TB0059 New Bellhousing & Coupling Arrangement for Standard Power Pack

Date: 20 Sept 07	Author: Neil Savage	TB0059	Cross Ref: K0005
------------------	---------------------	--------	------------------

TECHNICAL BULLETIN

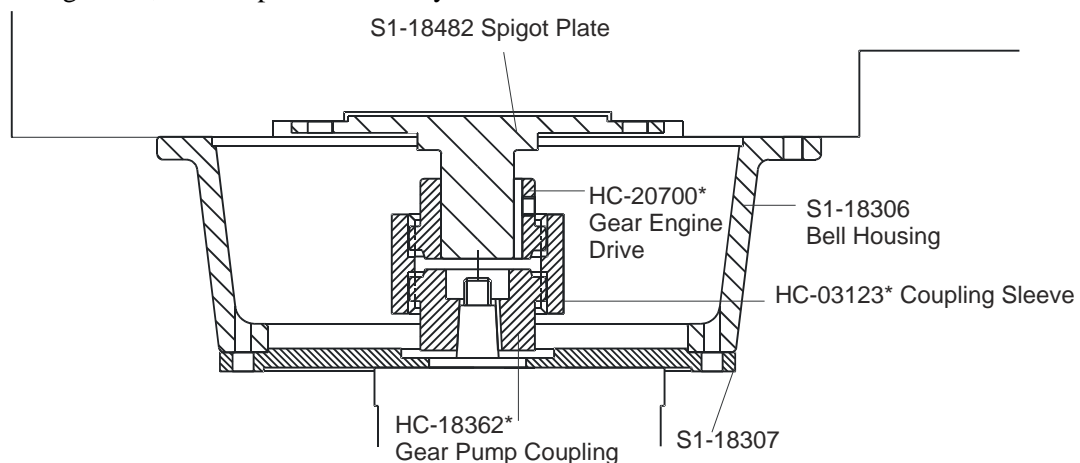
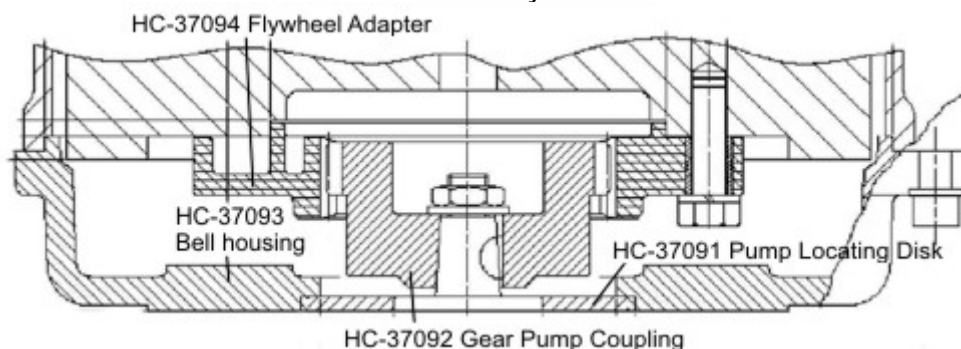
The standard powerpack on the Steelbro sidelifter has been changed to incorporate a new bellhousing and pump coupling arrangement.

Kit HC-37078 replaces the following items: S1-18306, S1-18307, S1-18482, HC-18793.

New bellhousing is self-locating onto the engine body which will reduce the possibility of issues with coupling caused by misalignment, and simplifies assembly/service.

*These three items make up kit HC-18793

Previous style

All items marked make up new kit HC-37078

The entire old coupling arrangement can be replaced by the new set up. Details on how to do this are in Service Info K0005.
